STAFF RECOMMENDATION

413 Bushnell Street

May 15, 2019

Application: New Construction—Infill

Figure 2. The massing study submitted by the architect prior to the official submission shows the second story wall stepped back from the front wall of the one-story portion of the house by several feet.

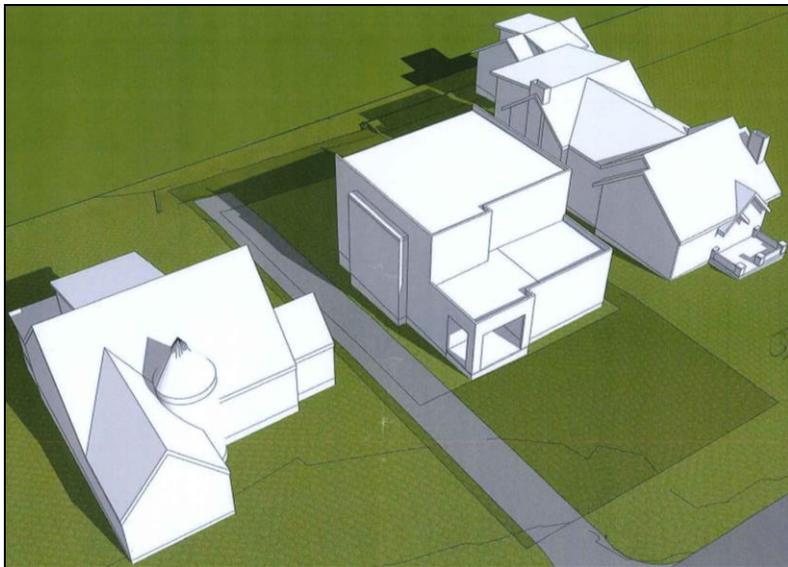
Height & Scale: The applicant proposes a two-story house. The predominant form along Bushnell Street is one to one-and-a-half stories. Staff finds a two-story form could be appropriate in this location for several reasons. The overall height of the house at twenty-four feet, six inches (24'6") from grade at the front is comparable to the heights of the two adjacent historic one-and-a-half story houses. In addition, the flat roof form helps to keep the overall height of the two-story form minimal. However, staff recommends that the two-story portion be pushed back further so that there is a one story portion beyond the front porch and the second story is behind the front wall of the house by several feet (Figures 2 & 3). Staff recommends that the second story wall be pushed back a minimum of eight additional feet (8') from the front wall of the first story (Figures 4 & 5).

With the condition that the second story wall be further pushed back, as shown in Figures 2, 4, and 5, staff finds that the height and scale meet the design guidelines.

1. The finished floor height be consistent with the finished floor heights of the adjacent historic houses, to be verified by MHZC staff in the field;
2. MHZC approved the front setback in the field prior to construction;
3. The second story be set back a minimum of eight feet (8') from the wall of the first story;
4. A walkway be added from the street to the front porch;
5. Staff approve the final details, dimensions and materials of windows and doors prior to purchase and installation;
6. Staff approve the color and texture of the vertical metal siding prior to purchase and installation; and
7. Staff approve the location of the HVAC and all utilities prior to purchase and installation.

Figure 3 is the proposed massing, showing the first and the second stories stacking on top of one another.

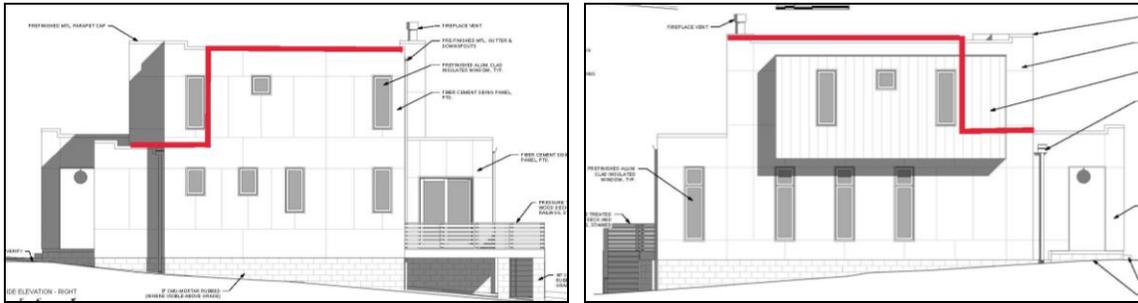
Figures 4 & 5 show the approximate outline of an 8' setback.

① FRONT ELEVATION
0 2' 4' 8'

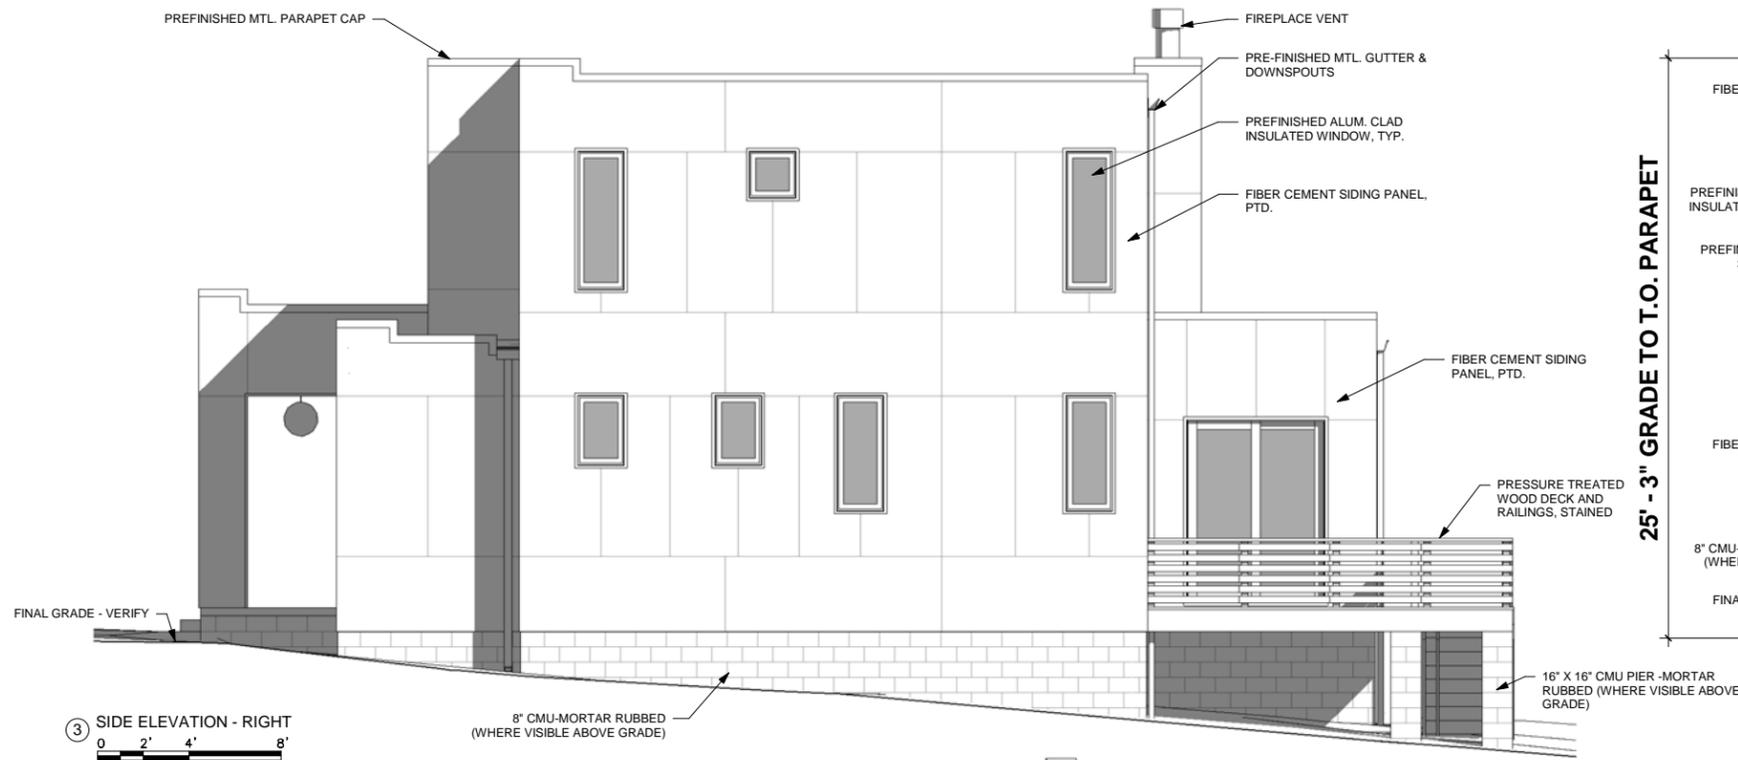
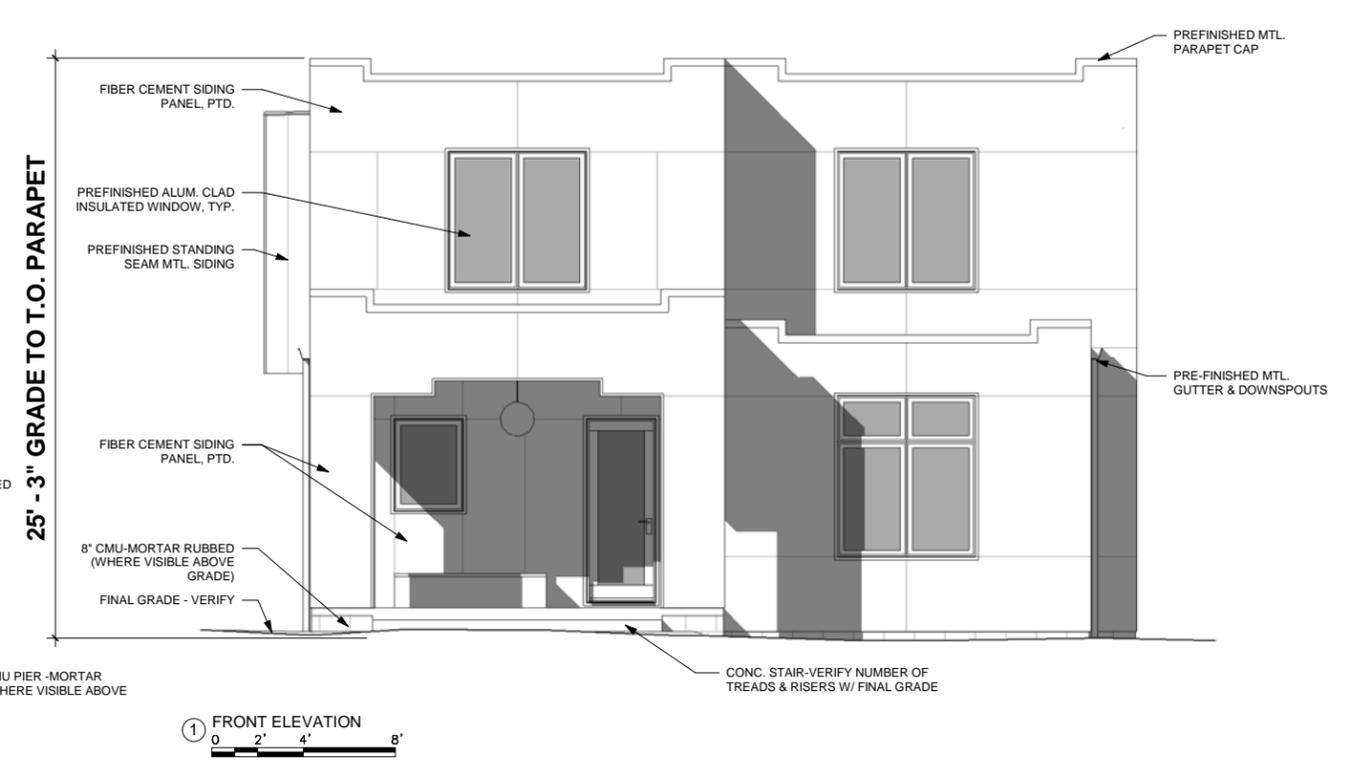
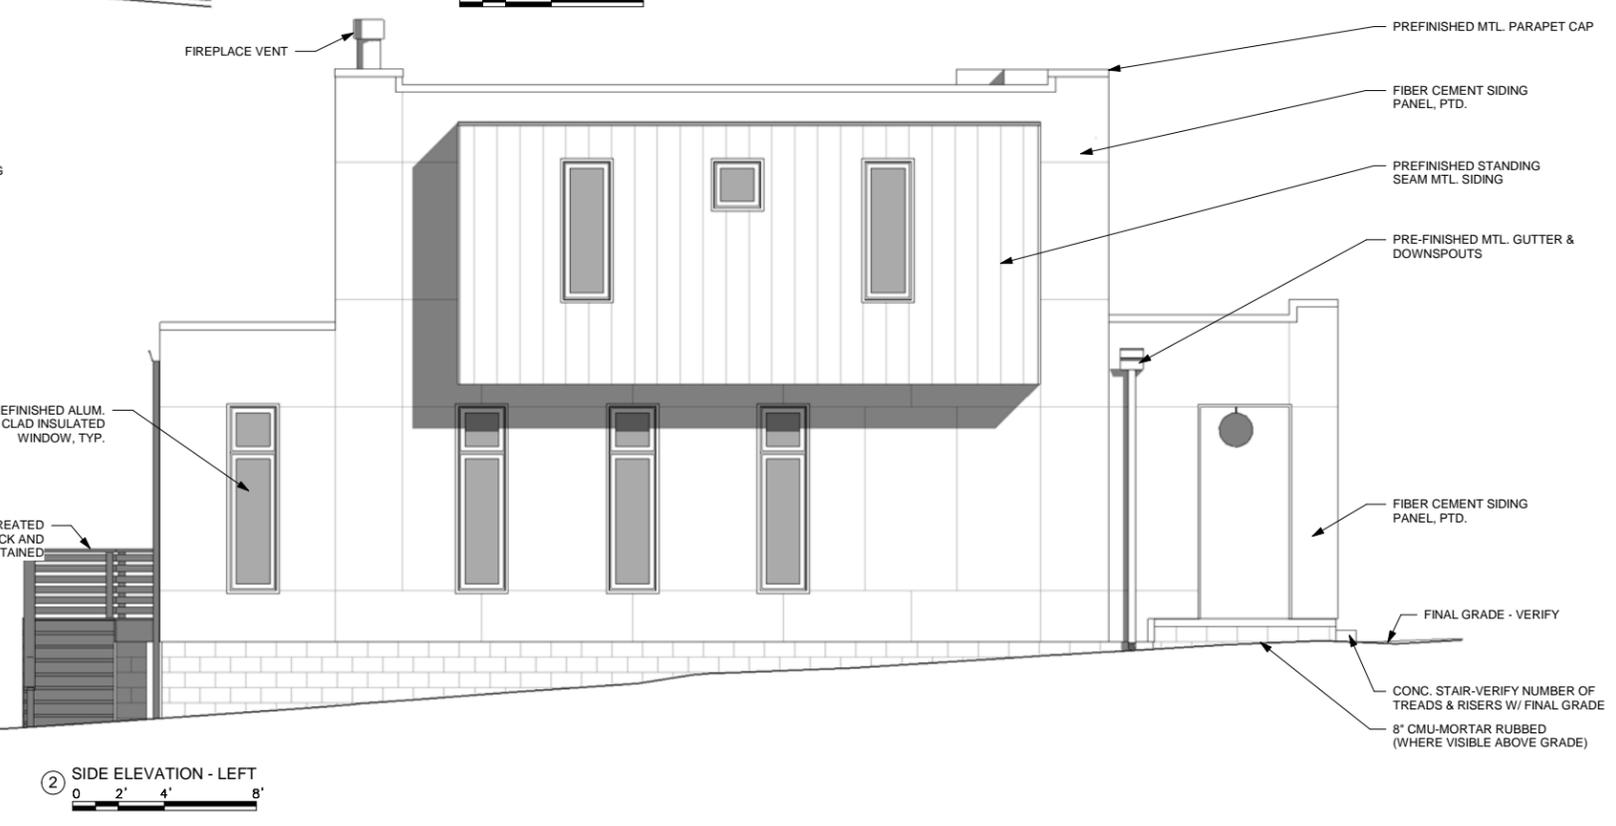
The proposed infill is primarily thirty-six feet (36') wide, and it is on a sixty-foot wide lot. On the right side, there is a second story projecting bay that adds an additional two feet (2') to its width. By comparison, the historic house at 415 Bushnell is also thirty-eight feet (38') wide on a wide lot, and the other nearby houses on sixty-foot (60') wide lots are approximately thirty-two feet (32') wide. Although on the higher end, staff finds that the proposed width could relate to the width of the adjacent house if the two-story massing, not seen in the immediate vicinity, is pushed further back.

**Vertical metal siding is not a typical material in the historic neighborhood. However, here it is used as an accent material, in a limited area. Spanish Colonial Revival houses were known for their decorative ironwork, so this metal accent material can be seen as a contemporary interpretation of the metal work seen on historic houses of this style.

With staff's approval of the metal siding color and texture and all windows and doors, staff finds that the infill's known materials meet Section II.B.4. of the design guidelines.

Proportion and Rhythm of Openings: The proposed windows are generally twice as tall as they are wide, thereby meeting the historic proportions of openings. There are no large expanses of wall space without a window or door opening.
